### 1 Products affected

Product Change Notification					OMH material change		
owner	creation date	release date	released by	change order no	rev	page	D10-006-925
dislercy	2016-07-26	2016-12-12	nowakfr	2009098	A	1 of 2

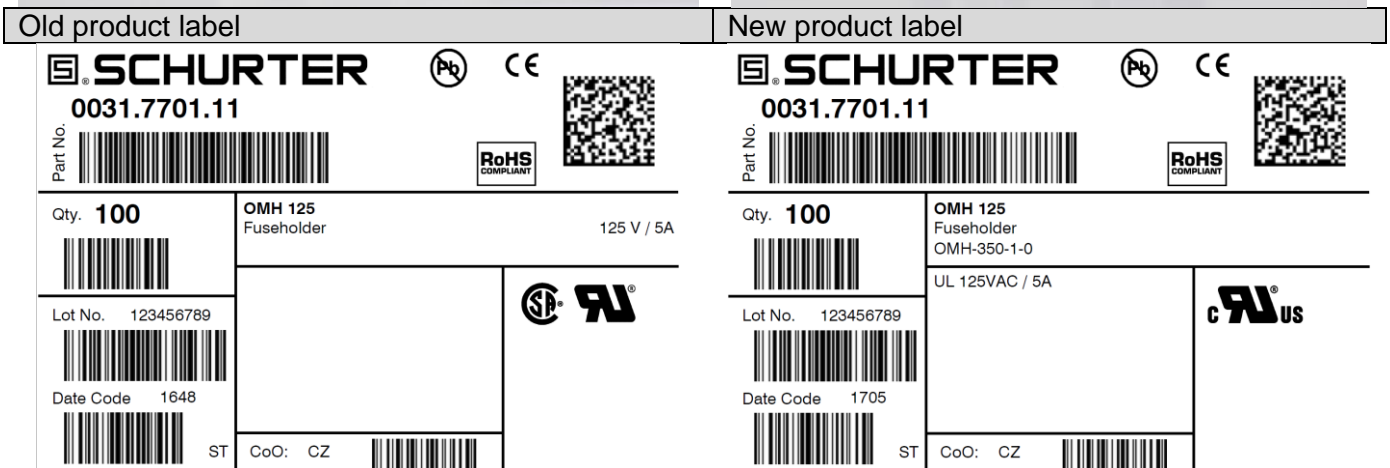
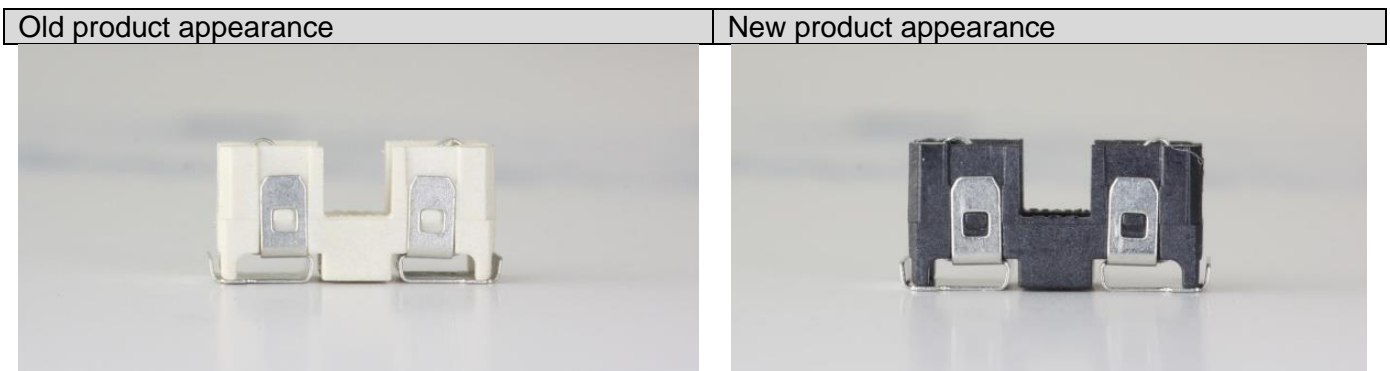
The isolation material changes from a white LCP to a black coloured LCP. The new material fulfils the glow wire requirements given in IEC60127-6:2014 and achieves reflow solderability acc. JEDEC J-STD020E (No moisture sensitivity – Level 1)

Product improvement to fulfil the enhanced glow wire requirements according to the updated standard IEC 60127-6:2014. Further, the new insulation material reaches the best moisture sensitivity level of 1 acc. to JEDEC which enables an unlimited floor lifetime of the surface mount device.

Form	Yes	Material of insulation changes
Fit	No	No change for dimension
Function	Yes	Moisture sensitivity level 1 acc. JEDEC J-STD020E
Manufacturing	No	No change for manufacturing site
Label	Yes	cURus mark; Electrical ratings; Configuration code on the label
Packaging	No	No change in packaging
